Jørn-Henrik Carstens, *Improved brakes on heavy vehicle combinations*

- amendment to UN-ECE regulation 13

Compatibility diagrams

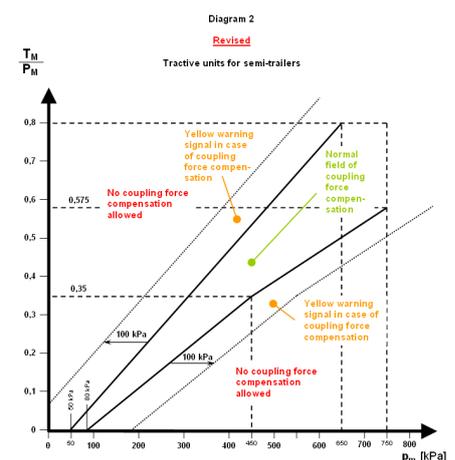
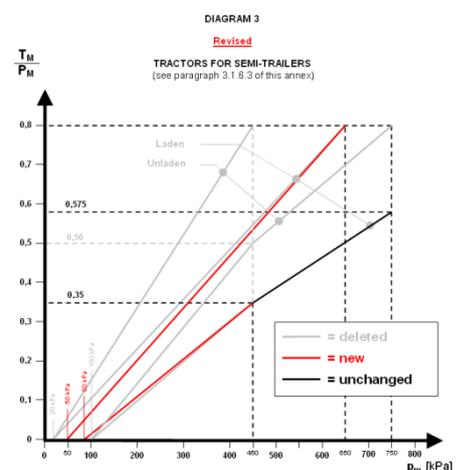
1. Unladen curves are deleted. Since there is a demand for ABS on HGV and the demands in annex 13 for vehicles equipped with ABS requires the corridors for the laden situation only fulfilled, the unladen curves are no longer relevant.
2. The starting points for the corridors are narrowed down to 50 kPa and 80 kPa respectively.
3. New corridor lines are drawn from new starting points to nearest existing point on laden curves.
4. In all load situations, other than the laden situation, the corridors apply, but only up to 200 kPa. That is to assure that not only will the start pressure fall within 50 and 80 kPa, but the brake rate will continue to develop in proportion to the control line pressure.
